3
Work Order ID 143971-2

Item Name: Tube

D212-725-1-937 TUBE ASSEMBLY

B	UPDATED PER 3D SCAN	DC	13.07.11
A	NEW ISSUE	RF	11.02.24
REV.	DESCRIPTION	BY	DATE
DESIGN	DC	DART AEROSPACE LTD	
DRAWN	DC	HAWKESBURY, ONTARIO, CANADA	
CHECKED	DC	DRAWING NO.	REV. B
MFG. APPR.	DC	D4257	SHEET 1 OF 2
APPROVED	DC	TITLE	SCALE
DE APPR.	DC	TUBE ASSEMBLY	NTS
DATE	13.07.11	COPYRIGHT © 2011 BY DART AEROSPACE LTD THIS DOCUMENT IS PRIVATE AND CONFIDENTIAL AND IS SUPPLIED ON THE EXPRESS CONDITION THAT IT IS NOT TO BE USED FOR ANY PURPOSE OR COPIED OR COMMUNICATED TO ANY OTHER PERSON WITHOUT WRITTEN PERMISSION FROM DART AEROSPACE LTD.

D212-725-1-213 TUBING

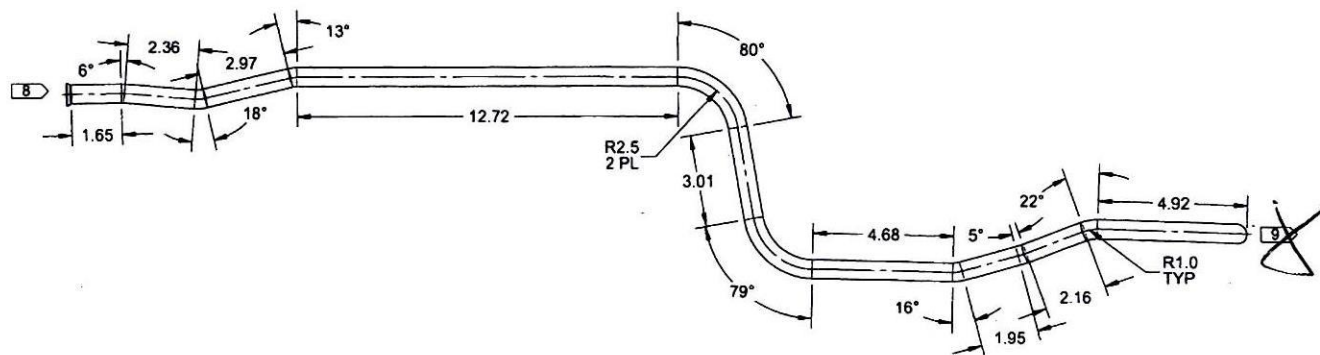
- 1) MATERIAL: AISI 304/316 SEAMLESS STEEL ROUND TUBING, $\varnothing 0.625 \times 0.035$ WALL
PER ASTM A213 OR ASME SA213 OR ASTM A269
REF DART SPEC. M304TR0.625W.035
- 2) FINISH: NONE
- 3) TOLERANCES: PER DART QSI 018 UNLESS OTHERWISE NOTED
- 4) UNITS: INCHES UNLESS OTHERWISE NOTED
- 5) BREAK SHARP EDGES: 0.005 TO 0.010 MAX
- 6) IDENTIFICATION: N/A
- 7) WEIGHT: 0.81 lbs
- 8) FLARE TUBE PER MS33584 THIS END
- 9) ~~OUT TUBE 45° AT THIS END~~

N/A: SEE ATTACHED EMAIL 16-05-03

Regarding D212-725-1-213/-937 tube assembly, it is acceptable to omit cutting the part to length at opposite end of nut/sleeve, and added 1" to 1.5" to the 4.92" and omit 45 degree cut.
